A Rejoinder to Criticisms of the Expert Opinion of Kenneth J. Goldstein, M.A., CGWP and Jeffrey W. Short, Ph.D. Regarding the Environmental Contamination From Texpet's E&P Activities in the Former Napo Concession Area Oriente Region, Ecuador

Chevron Corporation and Texaco Petroleum Company vs. the Republic of Ecuador

PCA Case No. 2009-23

SUBMITTED BY:
The Louis Berger Group, Inc.

Figure 3.3-4. Regression Relationship between Method 418.1 and Method 8015B Results

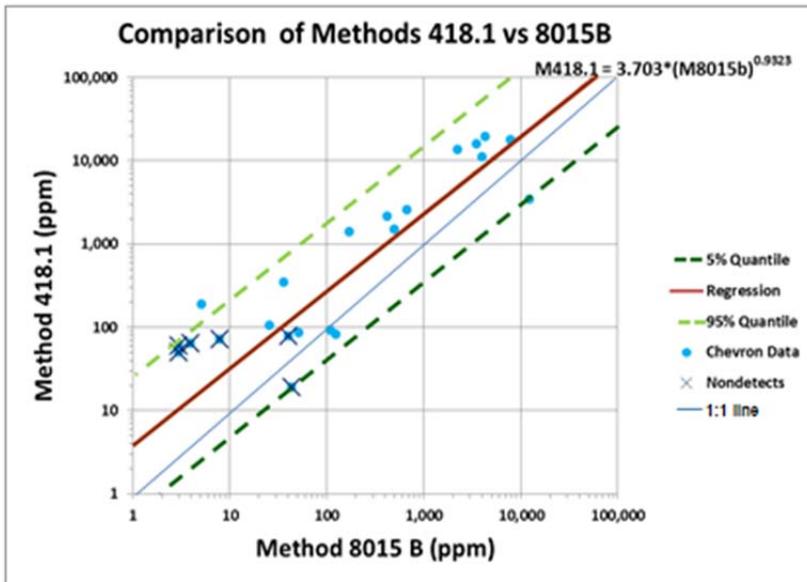
Hincee does not provide a definition of "accuracy" or "bias" to support his claims, and he misses the point that, in the RAP, infrared spectroscopy (i.e., *Method 418.1*) is the specified testing method.²¹⁸ Stating that *Method 8015B* accounts for most "compounds of environmental concern found in crude oil" is untrue: *Method 418.1* also detects these compounds as well as other compounds in crude oil that are of concern in the environment but not detected by *Method 8015B*. By choosing infrared spectroscopy, the criteria of the RAP already accounts for the range of compounds detected by *Method 8015B* and the broader range of compounds detected only by *Method 418.1*.

We used the set of Chevron data wherein both methods were conducted on a set of 22 samples,²²⁰ encompassing a broad range of TPH concentrations (less than 100 to greater than 10,000 ppm TPH by *Method 418.1*). Notably *Method 418.1* yielded a number of low concentration values, including several non-detects. A broad range of concentrations by *Method 418.1* would be unlikely if plant materials were a substantive fraction of the TPH by this method. That is, given the abundance of plant materials in the soils of the Oriente, if plant materials were a substantive fraction of the TPH concentration, there would be few low level concentration samples. Yet we observed many low level and nondetect samples in Chevron's limited *Method 418.1* data set (11 of 23 samples were below 200 ppm TPH by *Method 418.1* including 6 nondetects). The absence of substantive plant material in the *Method 418.1* results is also supported by the correlation of the two methods across concentrations, since *Method 8015B* is largely unaffected by plant material.

To demonstrate the low bias of *Method 8015B* with respect to the entire mass of petroleum contamination in a sample, a regression relationship was developed to predict *Method 418.1* from *Method 8015B*, see Figure 3.3-4. Refer to Appendix C for a detailed discussion of the development of this regression relationship. Because several of the *Method 418.1* samples were recorded as less than detection limits, a modified regression method designed to include nondetect data was applied. Based on this analysis, we conclude that in the range of greatest interest, close to the various regulatory permissible limits (500 to 2,500 ppm TPH in soil),²²¹ the results obtained by *Method 8015B* must be multiplied by a factor of 2.3 to obtain the concentrations that would be reported had *Method 418.1* been performed. Thus, samples obtained by Chevron that appear to fall below the various regulatory permissible limits based on *Method 8015B* could actually exceed these criteria based on *Method 418.1*. For example, in areas where the TULSMA Residential permissible limit of 2,500 ppm is appropriate, samples with reported values between 1,100 and 2,500 ppm TPH by *Method 8015B* likely represent locations that would exceed this permissible limit. Similarly, samples with concentrations in the range of 400 to 1,000 ppm TPH by *Method 8015B* are unlikely to represent locations that are actually below the RAOHE Sensitive Ecosystem permissible limit of 1,000 ppm. The latter example is illustrated in Figure 3.3-5.

result from *Method 8015B* is biased low and must be multiplied by a factor of 2.3 to convert it to a value consistent with the more accurate *Method 418.1*. The derivation of the regression is described in more detail in Appendix C.²²⁸

Figure 3.3-7 . Excerpt showing cleanup criteria at the Trecate site, note “Zone 2 ... 50 – 10,000 ppm” (i.e., mg/kg)

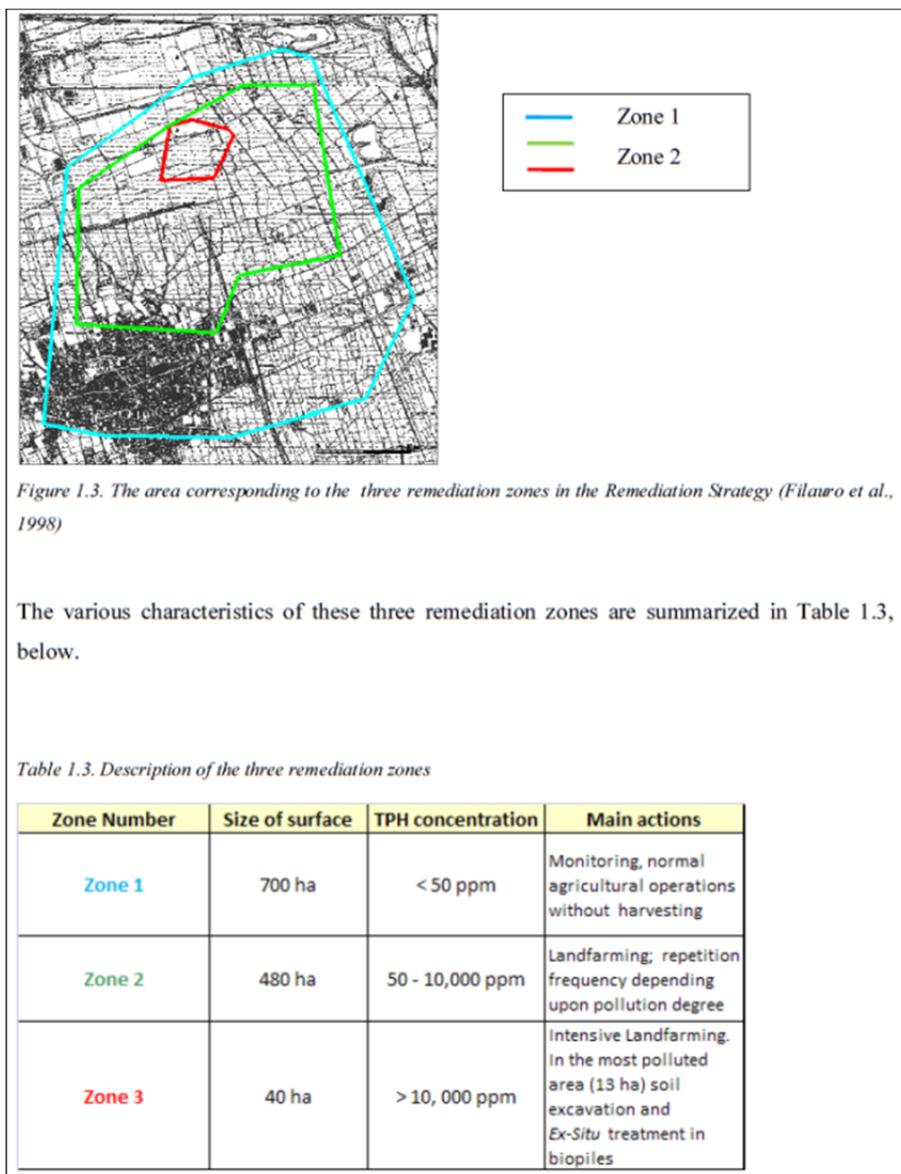
*The 100 mg/kg TPH cleanup standard used in the Judgment is inconsistent with current Ecuadorean cleanup standards, inconsistent with standards being applied to Petroecuador's remediation efforts, and, **in my experience, unprecedented for comparable crude oil cleanup anywhere in the world.***²³⁵ (emphasis added)

Figure 3.3-7 is an excerpt from the Greco, Toscano, Libisch, French, Hartnik, Anton, Biró; *Evaluation of remediation techniques Part 2: Trecate site* (2011) document regarding continued remedial efforts at Trecate (15 years after the blowout) that presents the remedial action and TPH triggers for those actions:²³⁹

**"Clean Perimeter" Assessment
 TPH Data
 Lago Agrio 15
 Figure 4.2-1**

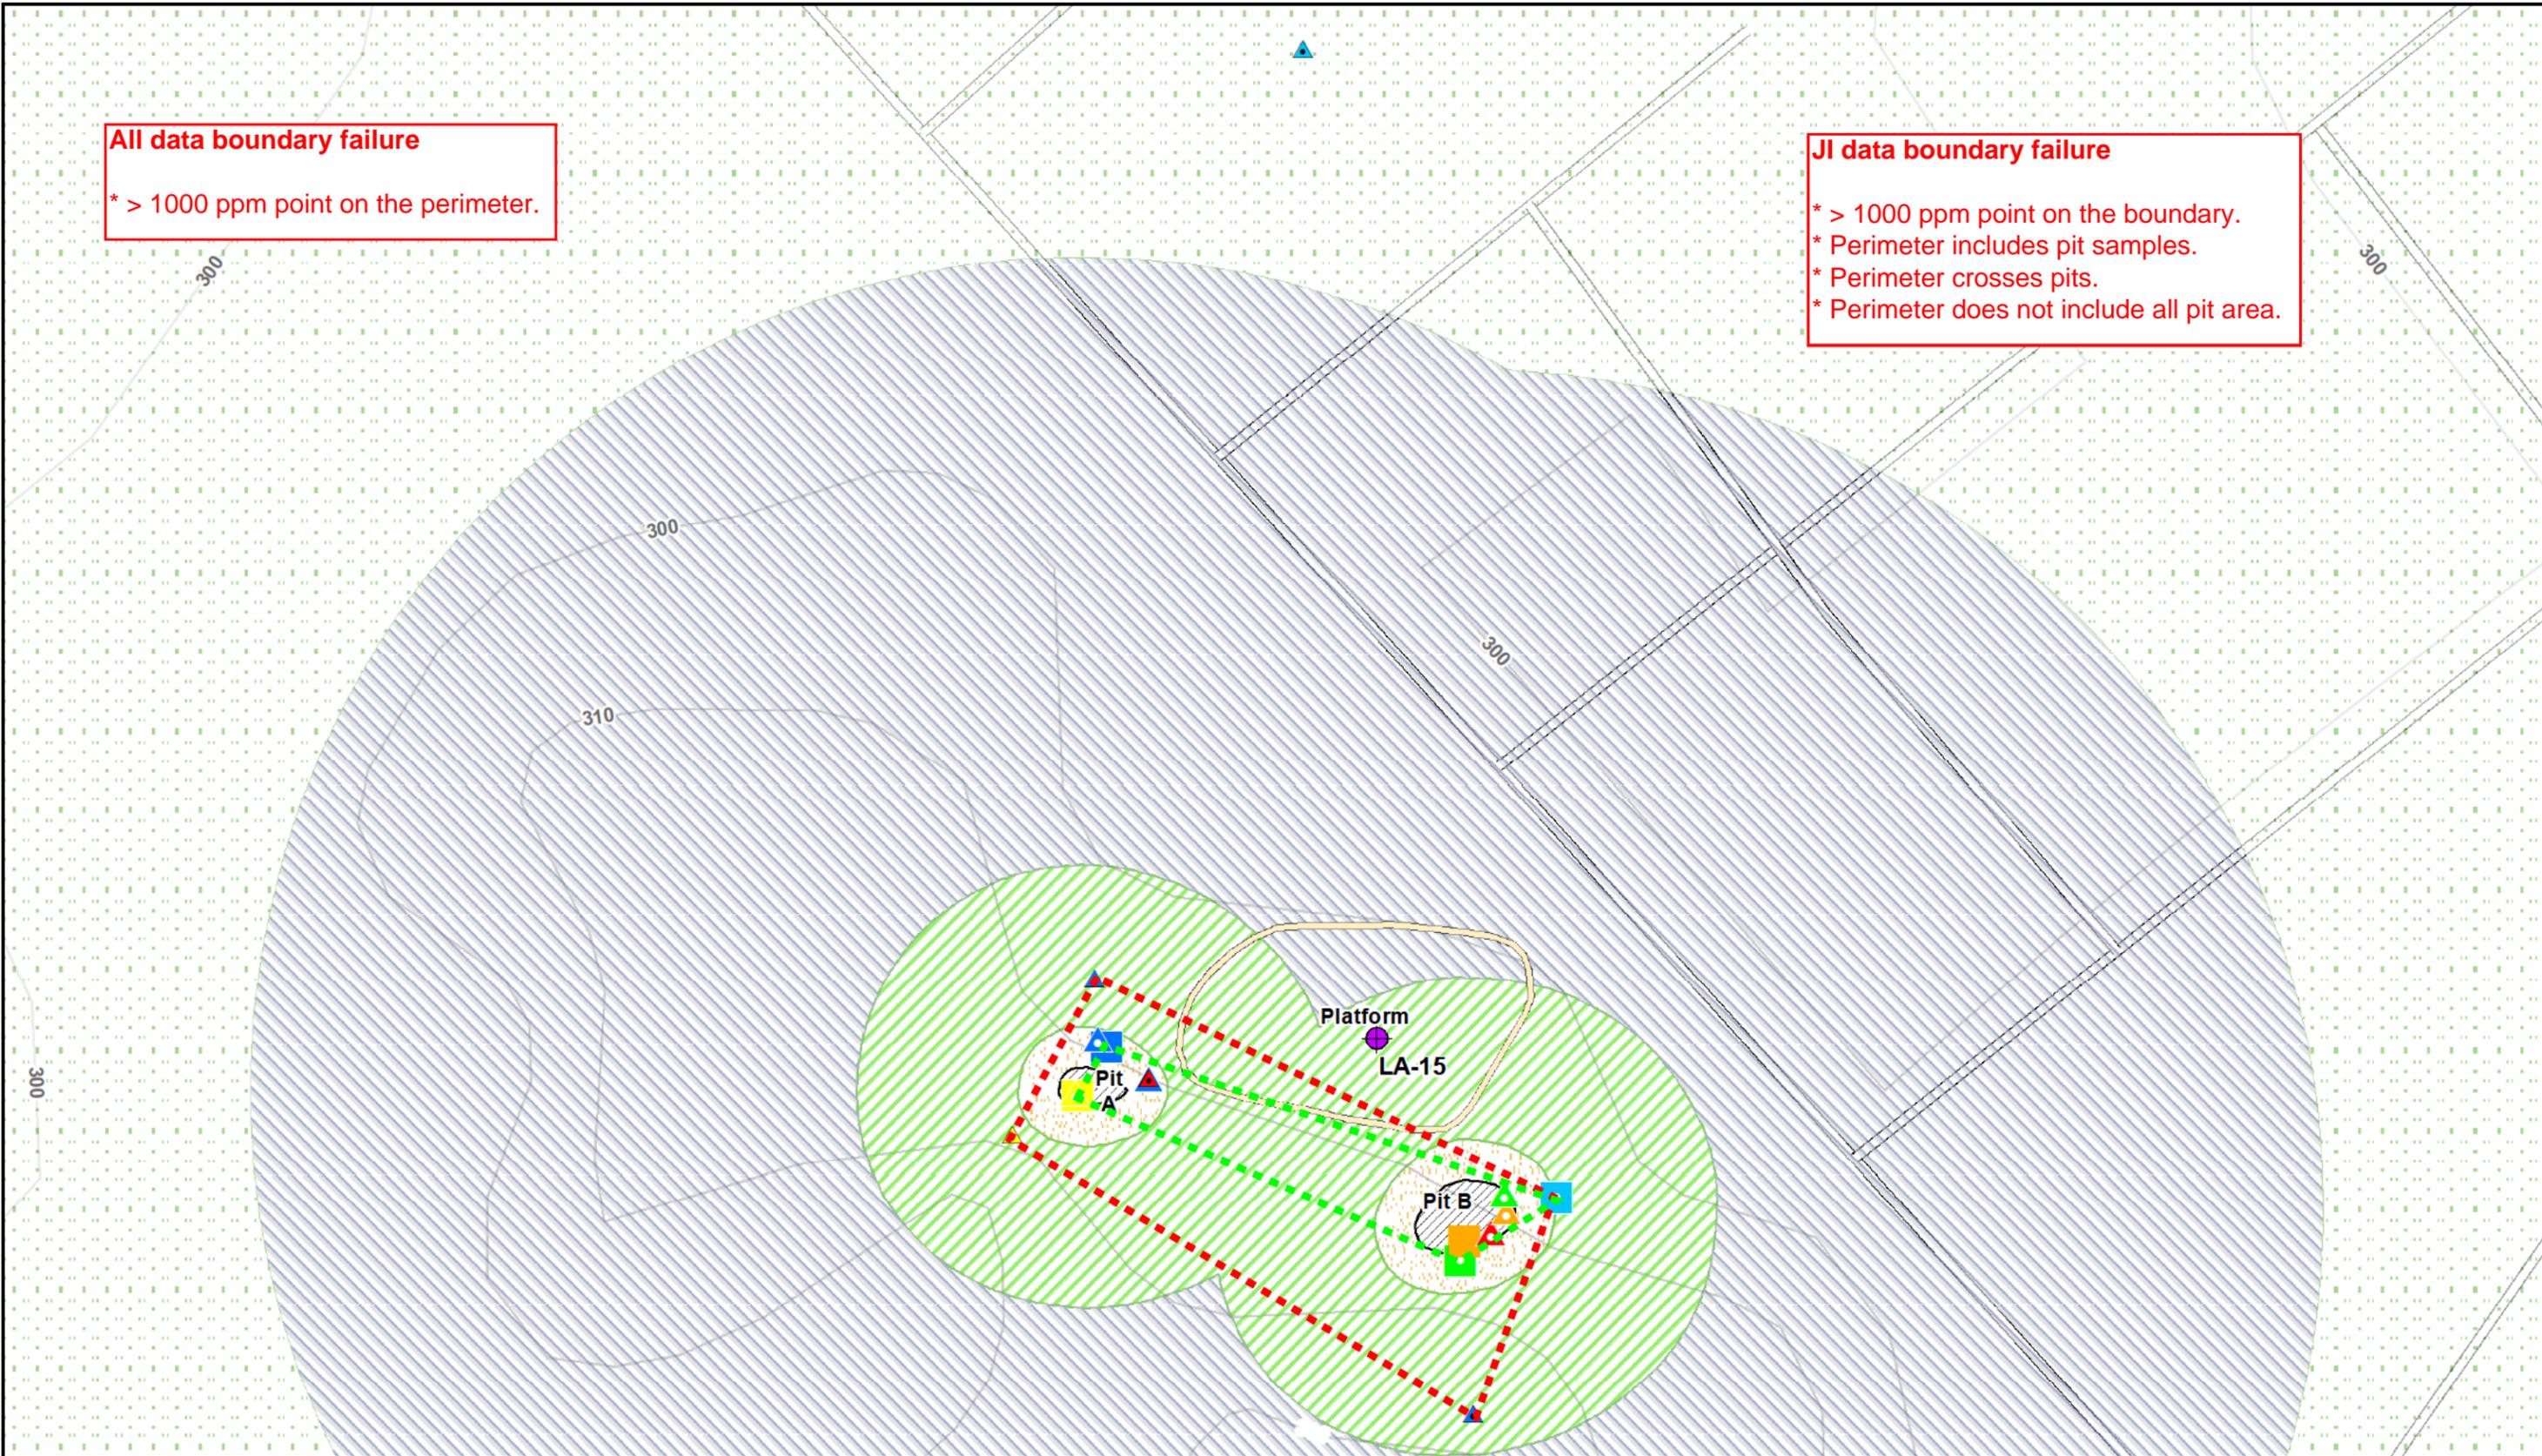
Affected Soil Areas Have Been Delineated: ...The areas of soils containing residual petroleum, either in Texpet-remediated pits or Petroecuador open pits, have been delineated with clean perimeter soil samples, which show that the affected soils are limited in area and do not extend beyond the immediate area of the oilfield facilities (production station or well platform).³¹¹

As discussed in Sections 4.2.1 and 4.2.2, for nearly all well sites the available data are too limited and too uncertain to characterize the local extent of contamination. The available data generally do not provide sufficient information to determine the average level of contamination in an area (*e.g.*, unremediated pit) nor do they form a basis to delineate areas above and below a given permissible limit. Although the data generally are too limited on a single well site basis,
